Errata Document for CY7C1312V18 & CY7C1314V18

This document describes errata for the CY7C1312V18 and CY7C1314V18. Details include errata trigger conditions, available workarounds, and silicon revision applicability. This document should be used as a supplement to the existing datasheet.

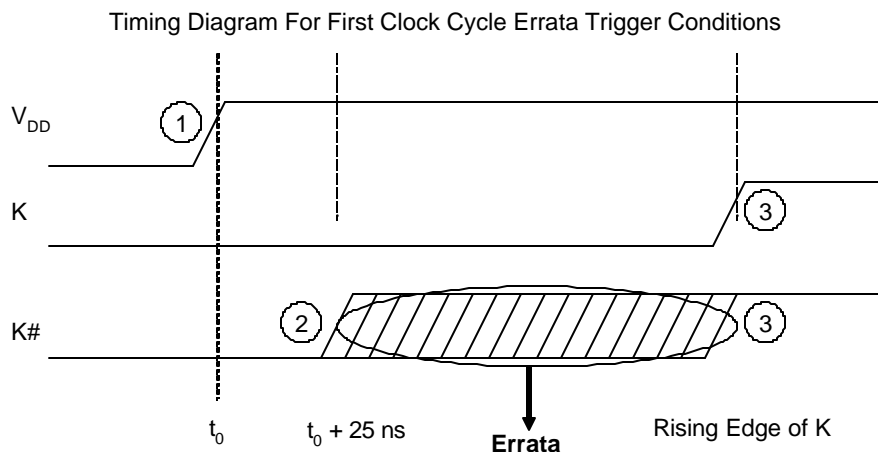
- (1) V_{DD} reaches 1.7 V at t_0 ,
- (2) K# rises from low to high after $t_0 + 25$ ns,
- (3) K# rises from low to high before the first rising edge of K.

A timing diagram for these trigger conditions is shown below:

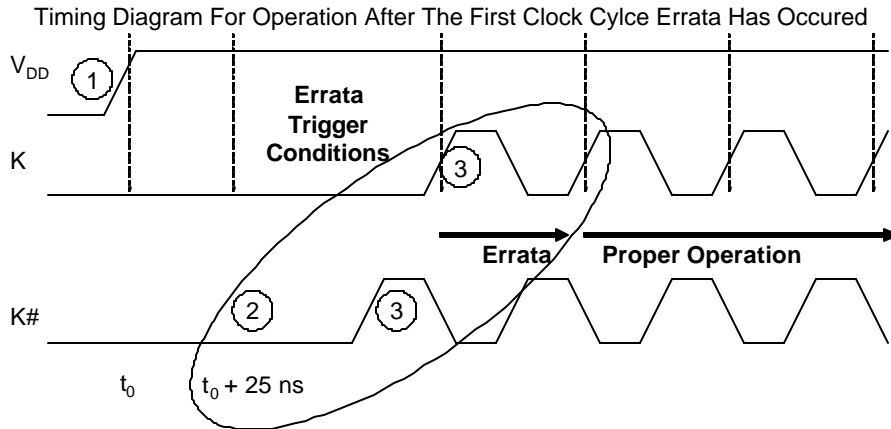
A timing diagram describing device operation after the first clock cycle errata is triggered is shown below.
